FERC Project No. 10855
NATDAM Nos. MI00197 & MI00175

Dead River Hydroelectric Project: Silver Lake and Hoist Developments

Article 402 – Planned Deviation of License Start of Month Target Elevations

Figure 1: General representation of model development and resulting components of interest, including data inputs, parameters, assumptions, statistics, calibration and validation processes

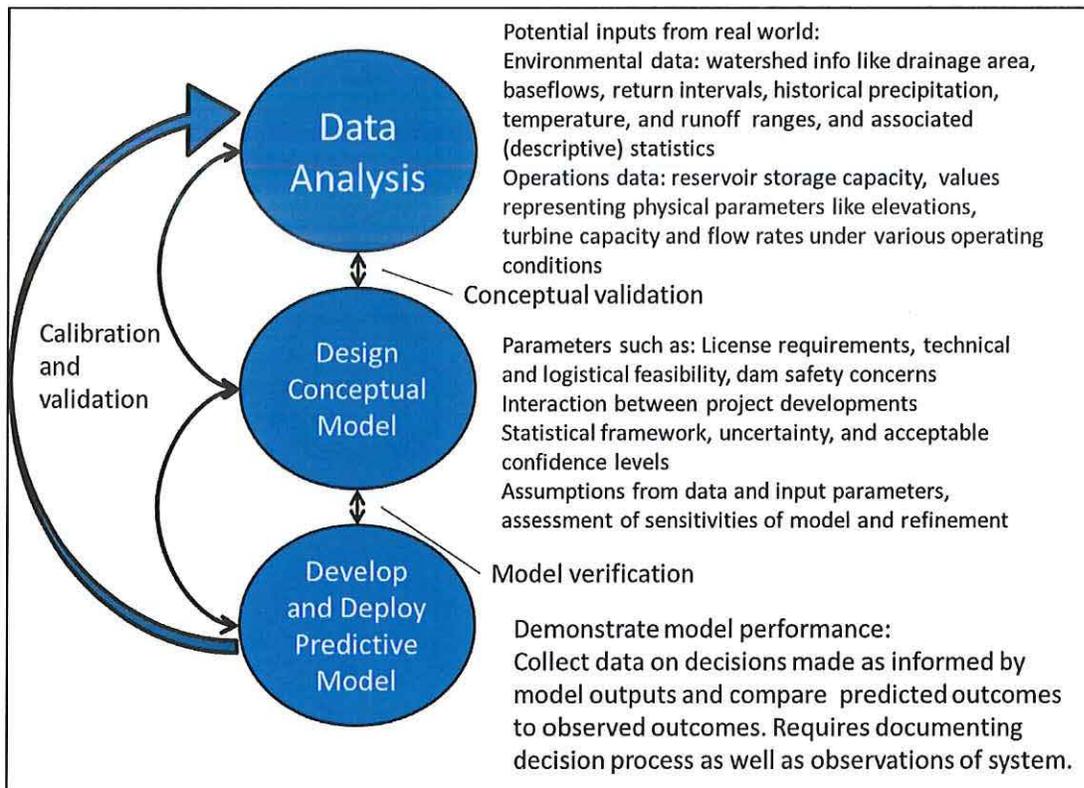
UPPCO has occasionally referred to using a model for the Dead River, for, among other things, justifying deviation requests. Commission staff referenced the development of a model in FERC's March 11, 2010 Order Modifying and Approving Article 405 Operations Monitoring Plan. MDNR has sought clarification numerous times on details of UPPCO's "hydrologic model;" what data are 'inputs' in the model, what are the assumptions of the model, what statistical framework is the model built on, and on the same path, what parameters are included and not included (how were these determined, with what sensitivities), what confidence is associated with model outputs, among others. Essentially, all attempts to answer the question "Does UPPCO have a predictive hydrologic model, what does it answer, and how does it work?" are avoided, or answered with a level of ambiguity that MDNR cannot accept, or are explanations of plans for operation (e.g. deviation requests) that merely allude to having used the model.

Figure 1 provides a simplified representation of how a hypothetical model might be developed. It is intended to point out some features that might be included in models such as that UPPCO has referenced. Figure 1 also speaks to some facets of model development, calibration and verification that would be useful in understanding model applications and efficacy.

If UPPCO has a predictive model that it is using, UPPCO should also be able to provide verification data similar to what other entities do for their predictions, to improve over time and know how much confidence to place in the outputs and under what circumstances. If UPPCO is using a non-predictive model, and is weighing it among other factors, those should be documented and tracked as well, and compared to what actually happened.

Because of the many ways models can be used, the many forms they can take and the components they consider, sharing the model, the context of its development and associated metadata would be part of a broader valuable conversation, and it is difficult to describe all the features of interest without having a firm grip on whether the model exists, how it is being used and what questions it is supposed to help answer.

Figure 4: National Oceanic and Atmospheric Administration, National Operational Hydrologic Remote Sensing Center Snow Water Equivalent vs time for a February – June time period

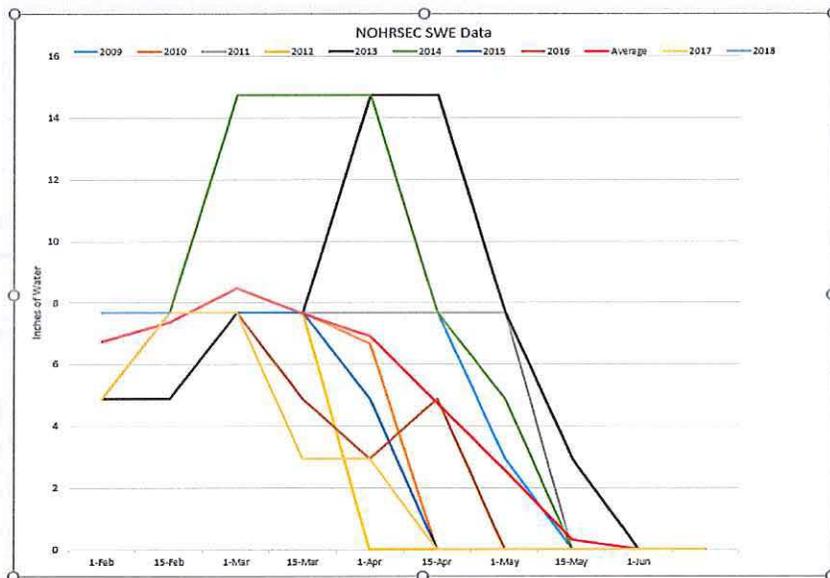
The graph in Figure 4 was presented as an image which prevented agency staff from being able to trace overlapping series. This graph has some useful components (showing variability in when most of the water on the landscape as snowpack melted in the last 10 or so years), but doesn't tell agency staff much about what this year might look like. At the time of the meeting-March 1, the majority of the series were potentially 'similar.' At the time UPPCO requested comments on a planned deviation; no update was given to suggest any of the options had been eliminated. There is no way of knowing whether more data would follow similar paths, or what conclusions agency staff are supposed to draw from this presentation, or how it relates to the tables above, or the model UPPCO refers to, which Commission staff incorporated in the 2010 Order.
